Kyoto **energypark**

Supplement to Environmental Assessment Responses to Public Submissions

Responses to the Public submissions received during public exhibition of the Kyoto Energy Park proposal in accordance with Part 3A of the Environmental Planning and Assessment Act 1979.

Figure 1.1 Satur Village diversion via the existing Haul Road on Middlebrook Station

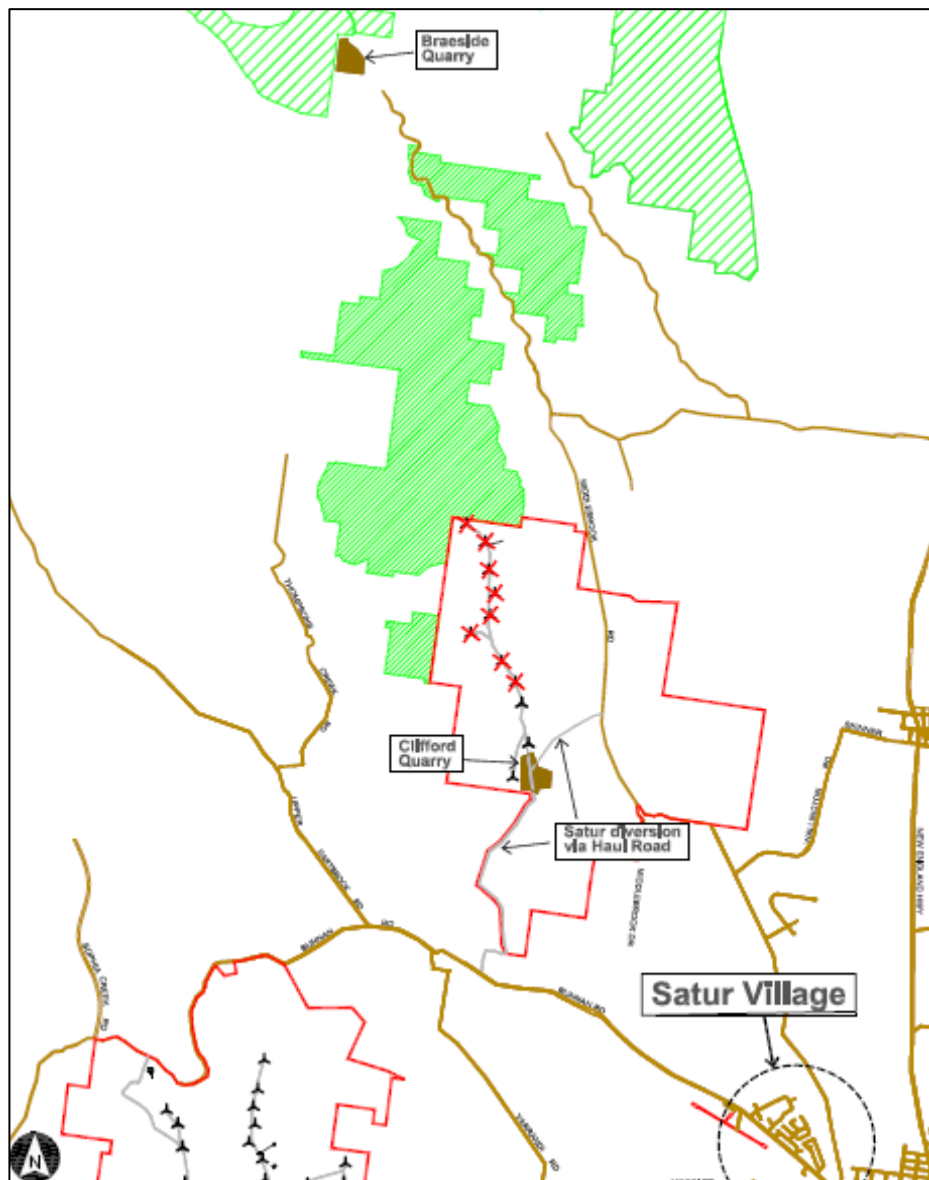
Road base material will be required to upgrade existing internal access tracks on both sites. An option exists to source this material from the existing Clifford Quarry operations on Middlebrook Station (see Figure 1.1 below). In addition, there is an option to source concrete aggregate and materials from the Braeside Quarry operation north of the site as shown in Figure 1.1 below. Both of these operations are owned by Clifford Quarries. Braeside Quarry supplies quality concrete aggregates and blending sands to the market. An option exists to utilise the quarry for supply of concrete aggregate for foundations and concrete works and blending sands for trenches.

The existing haul road at the entrance to Middlebrook Station is currently managed by Clifford Quarries under agreement from the landowner. Additional truck movements have been included in the EA. Dust mitigation measures would be sufficient to control dust at this section of the haul road during the limited period during which time the haul road would be used.

Figure 1.3 Location of Aboriginal Objects in relation to Middlebrook Station (Myall Coast Archaeological)

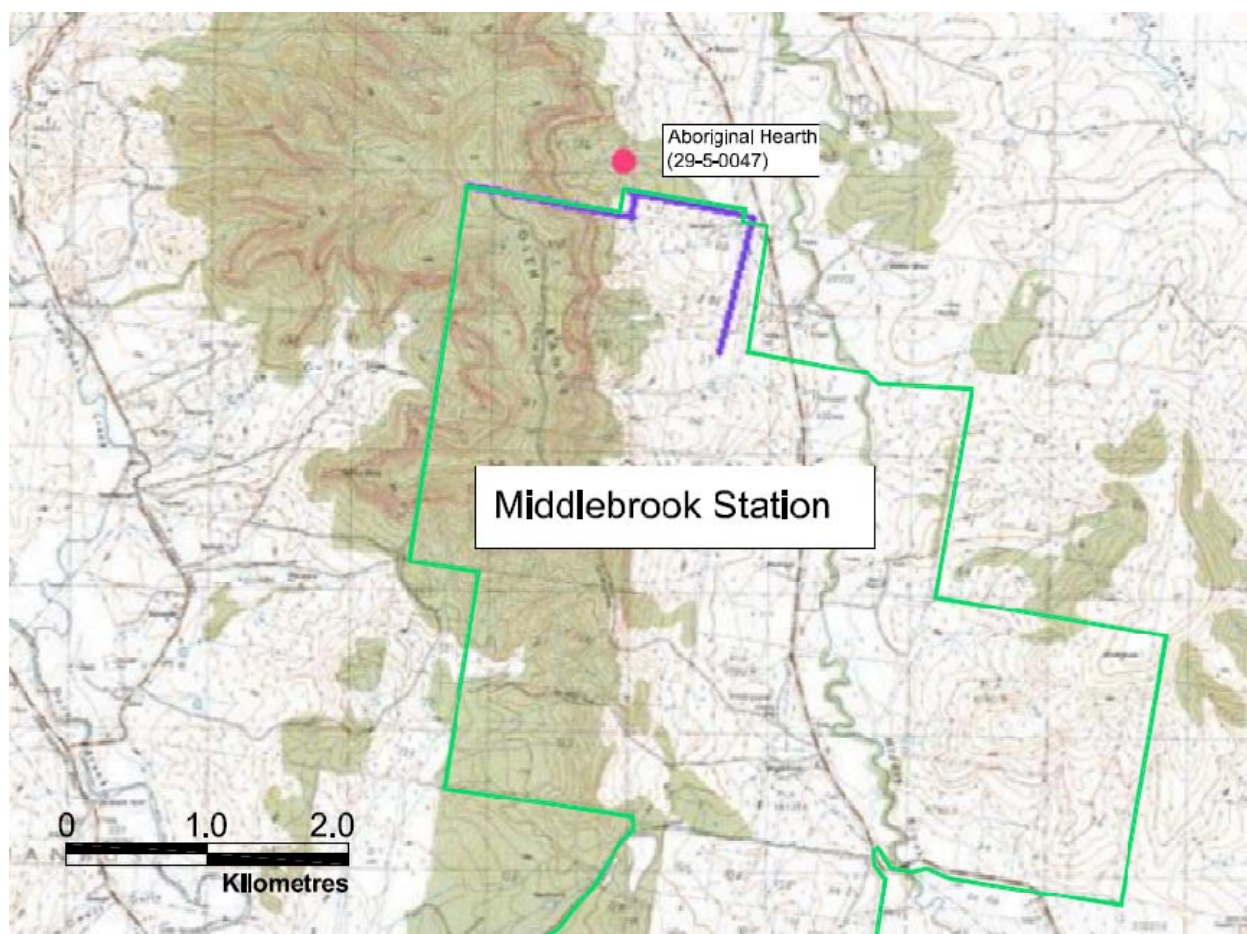
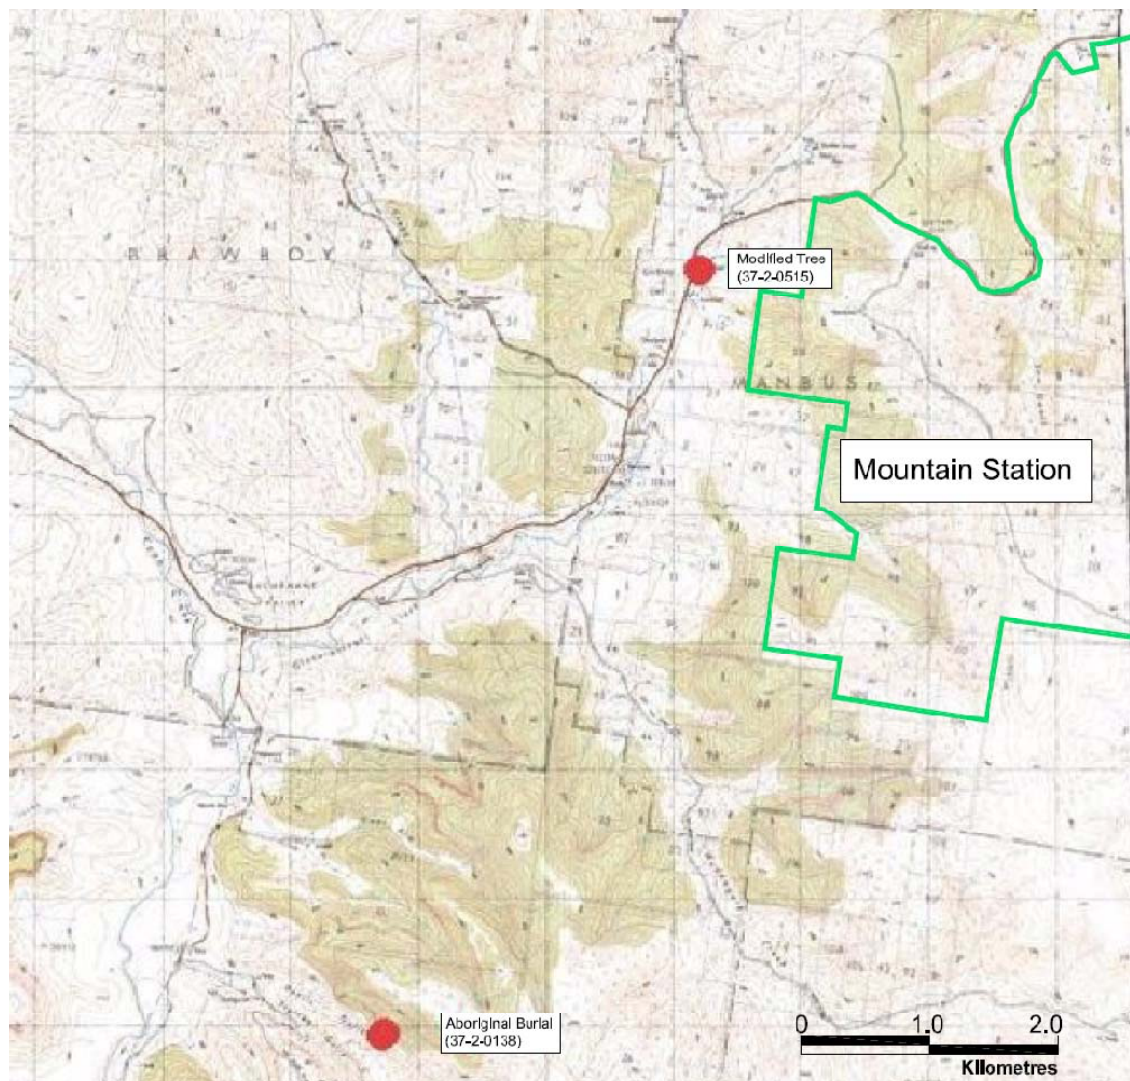
The DECC have referred to three known Aboriginal Objects known as an Aboriginal Burial (37-2-0138), a modified tree (37-2-0515), and an Aboriginal Hearth (29-5-0047). With respect to the objects specifically referred to in the comments from DECC they have been marked on the following map supplied by Myall Coast Archaeologists (see Figure 1.3 and 1.4 below). The modified tree and Aboriginal burial were considered in the EA submitted for public exhibition and are actually some 2.3km to 4.5km from the closest turbines respectively. These items are outside the limits of the site boundaries as shown in the figures below and therefore are not considered to be in the close vicinity.

The burial in question (Figure 1.3 below) is located near water and in a completely different landscape. This particular burial is typical of the characteristics required for burials as discussed in the report and was taken into account. It was not specifically mentioned as it was 4.5km away and bore no special relevance to the study area as described above.

The Aboriginal Hearth (fireplace) is located north of Middlebrook Station as shown in Figure 1.4. It is approximately 500m to the north of the northern property boundary and approximately 3.3km from the closest proposed turbine in a straight line. However it cannot be accessed from the ridgeline in a straight direction as it is on a footslope some 250 metres below a steep escarpment. This object was not identified on the original searches. It could be because it was outside the initial search, however should have shown up on the 20km search.

Figure 2.0 Final Layout of Proposed Facilities (Mountain Station)

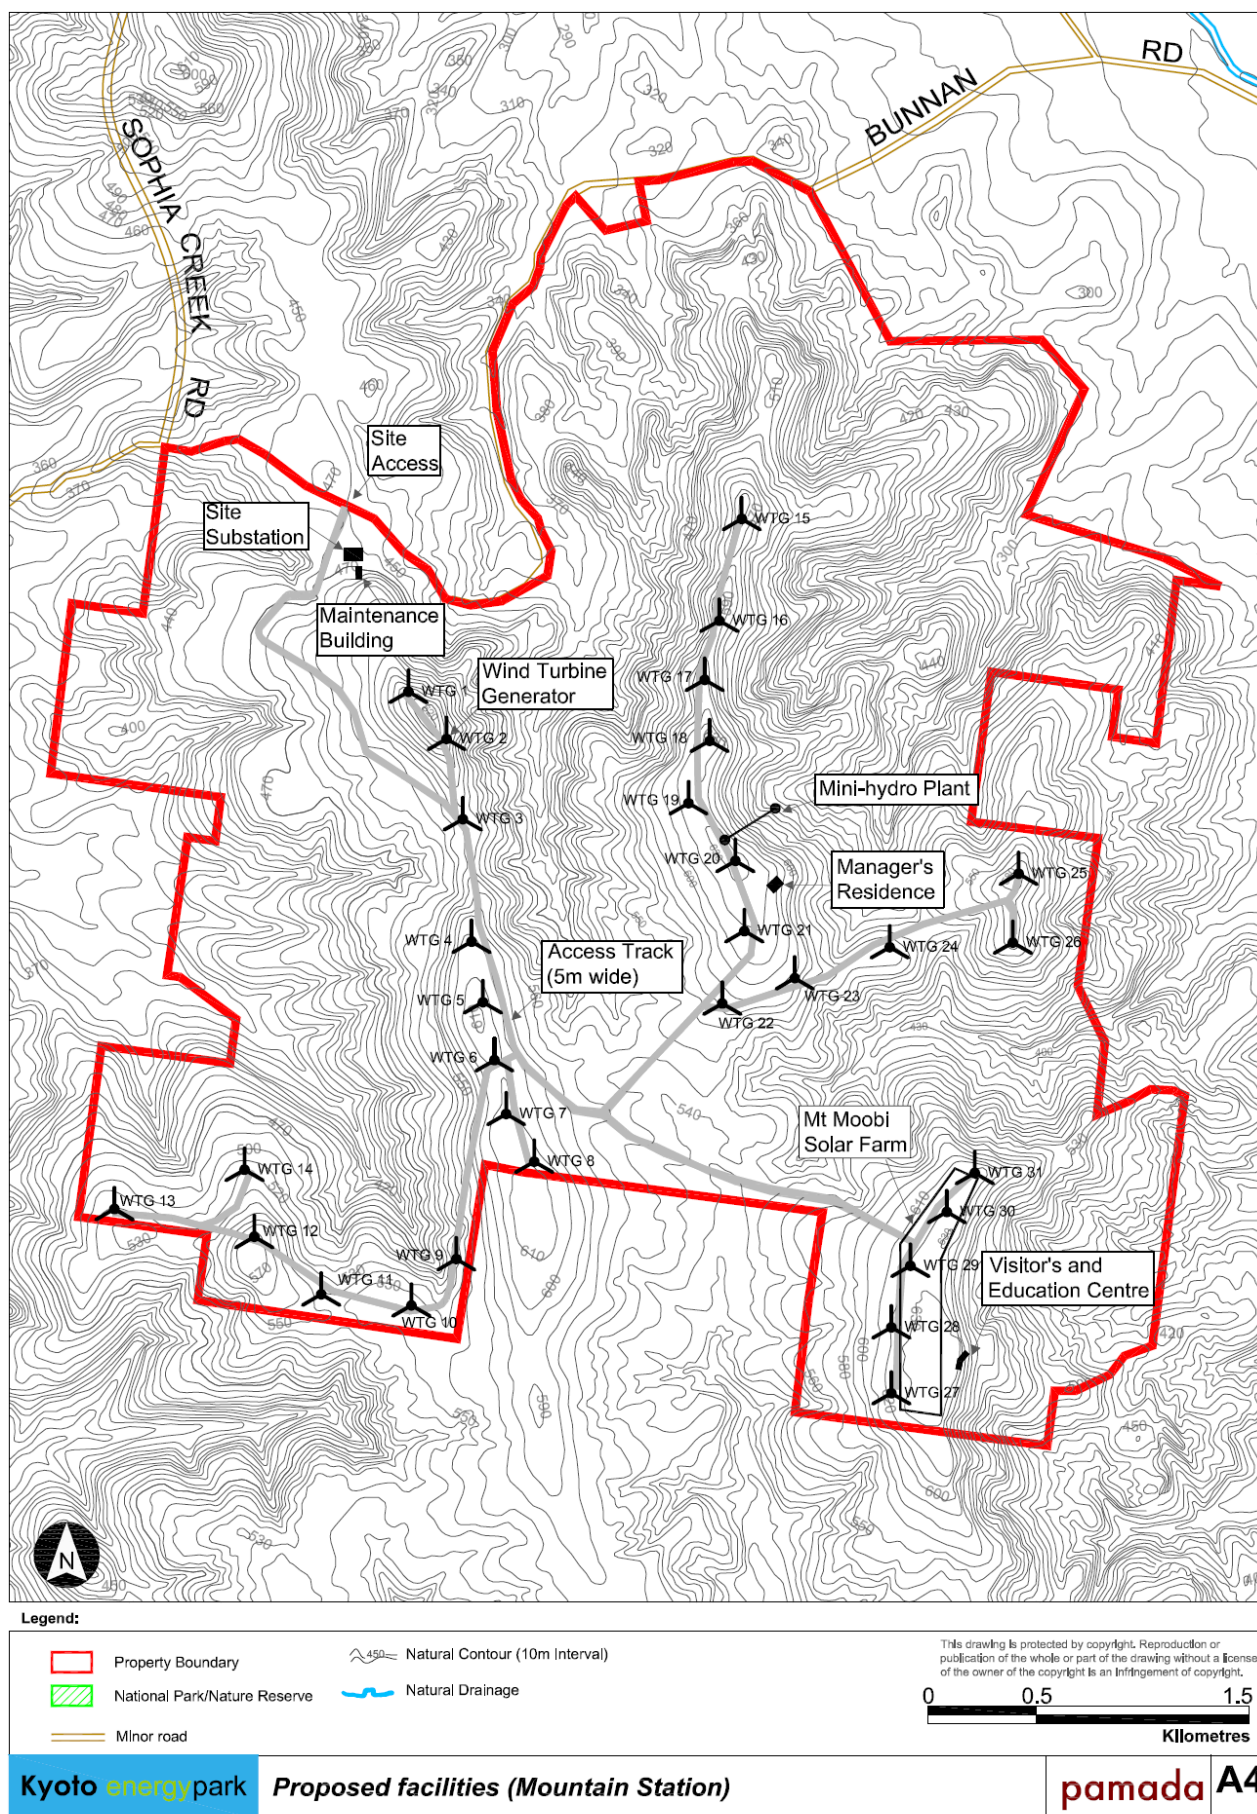
As of July 2009 Pamada have resolved to remove an additional 8 turbines from the Glen Range ridgeline behind the Castle Rock formation. Significant numbers of concerns were received from residents directly west of the Castle Rock formation and Middlebrook Station during exhibition of the EA. Removing these additional turbines would eliminate the visual integration concerns when viewing the Castle Rock formation from a west and south west position. Other distinctive rocky formations were identified along this western escarpment, mainly to the north of Castle Rock. Castle Rock is not a recognised tourist attraction currently within the area.

Proposed facilities on Mountain Station are illustrated in Figure 2.0.

Figure 2.1 Final Layout of Proposed Facilities (Middlebrook Station)

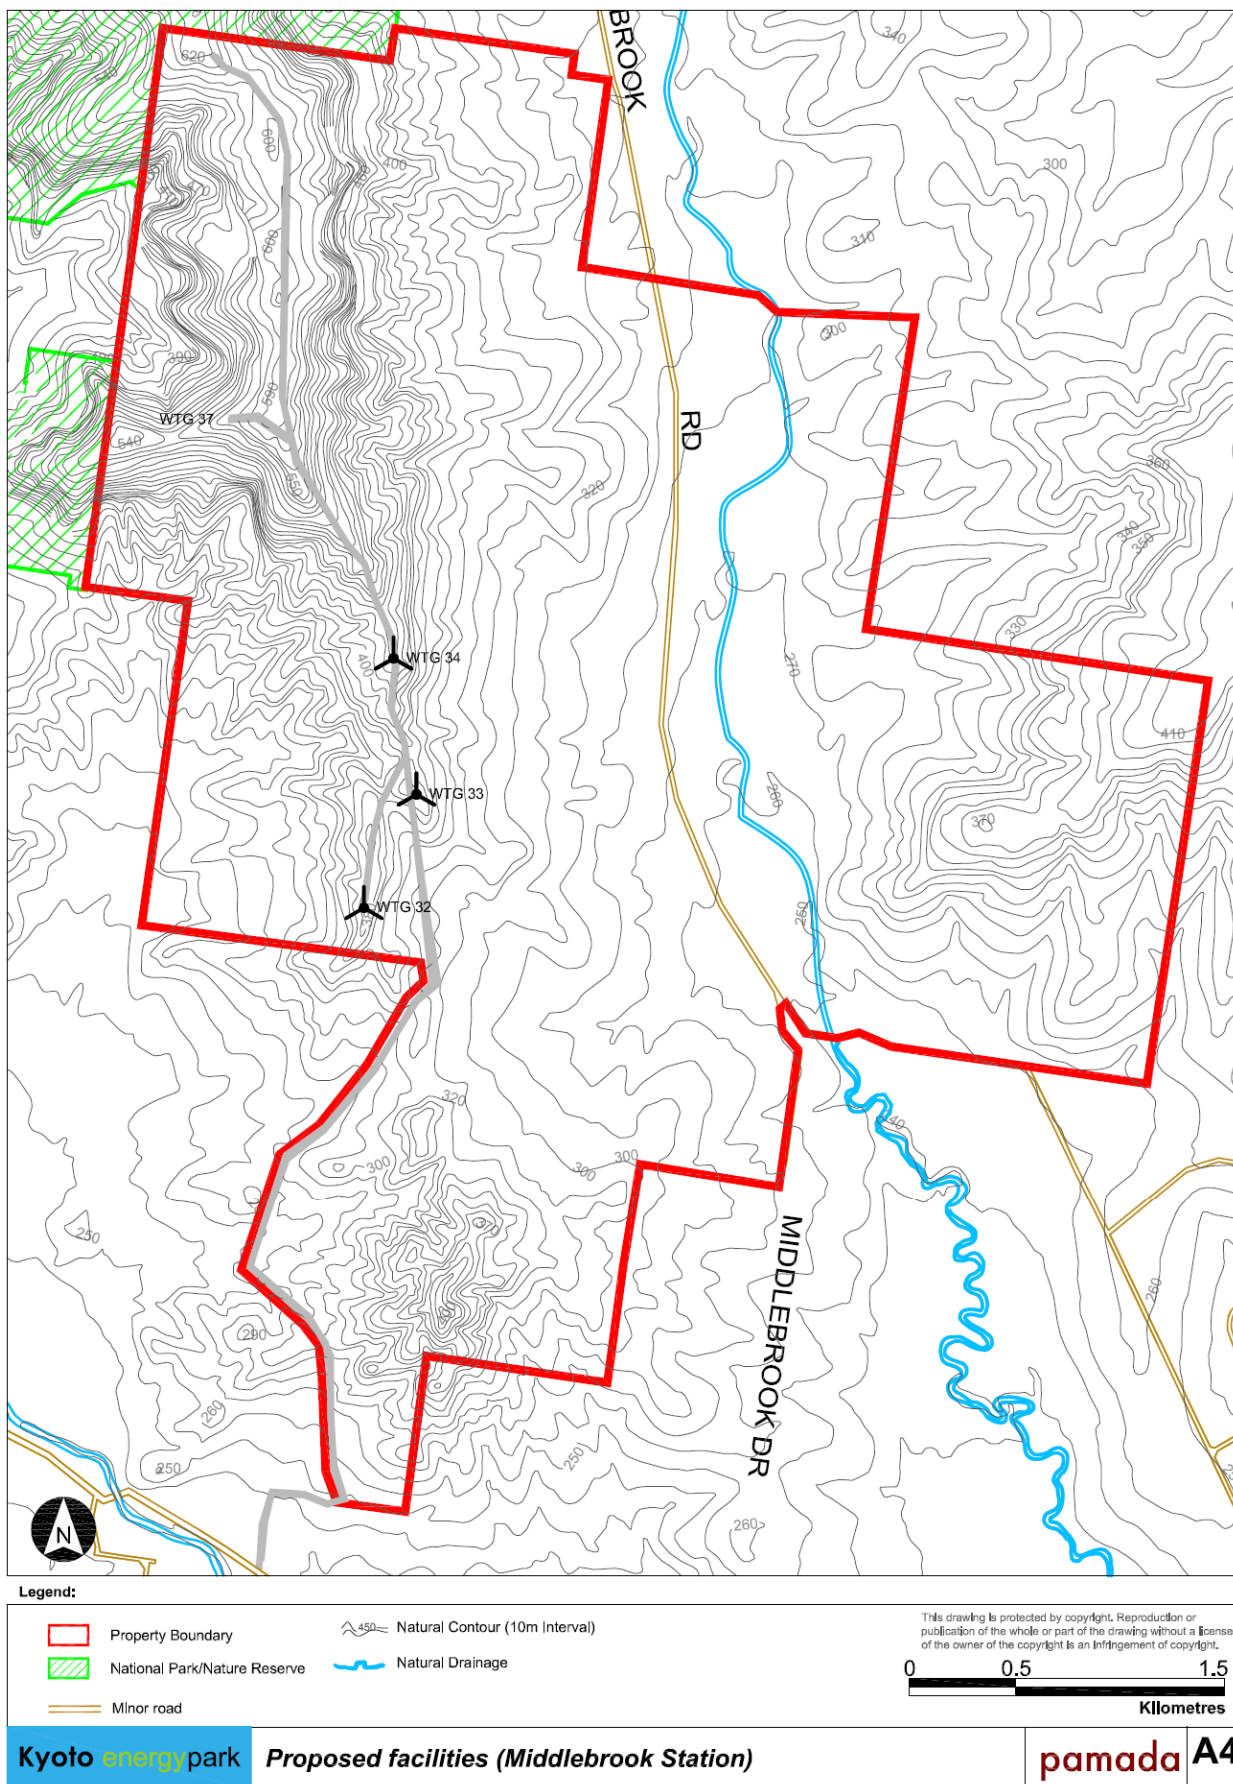
It is proposed to remove 8 turbines from the Middlebrook Station site closest to Towarri National Park (see Section 3.0 – Final Layout). Removal of these turbines from the proposal will significantly reduce the amount vegetation modification, clearing and disturbance on Middlebrook Station in closest proximity to Towarri National Park.

Proposed facilities on Middlebrook Station (revised) are illustrated in Figure 2.1 above.
